**FIELD SERVICE BULLETIN**

FSB Number: LVCCFSB2006-287  
Author: Tony Bryan  
Date: July 07, 2006  
Total No. of Pages: 3  
Subject: GSM PEBL U6 – Intermittent Alert Audio (Pogo-Pin)  
Phone Models: GSM PEBL U6  
Level of Repair: 3

X-Ray image of U6 Pogo-Pin (3988194N07)

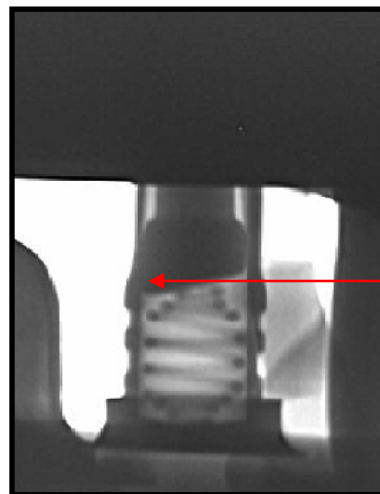
Service is aware of an issue identified in the NPI Analysis of the GSM PEBL U6 product. Some units, returned with customer complaints of “Alert– No Ringtone” and other related alert audio complaints, were found to be caused by poor mechanical connection internal to the alert pogo-pin connector (3988194N07). This failure mode is extremely intermittent and can be recovered and induced by flexing or shocking the rear housing in the area of the alert speaker. The root cause has been determined to be insufficient Nickel (Ni) and Gold (Au) plating on the pogo terminal inner surface and a low contact force between pin and pogo terminal inner surface.

Mechanical Connection Point

- (1) 100% inspection of terminal plating and connector resistance implemented at supplier site on March 20th.
- (2) A re-design of the 3988194N07 pogo-pin was completed to increase contact angle from 15 degrees to 20 degrees. The increase in contact angle will provide a higher side contact force internal to the pogo-pin.

#### **New Pogo-Pin Part Number: 3988194N14**
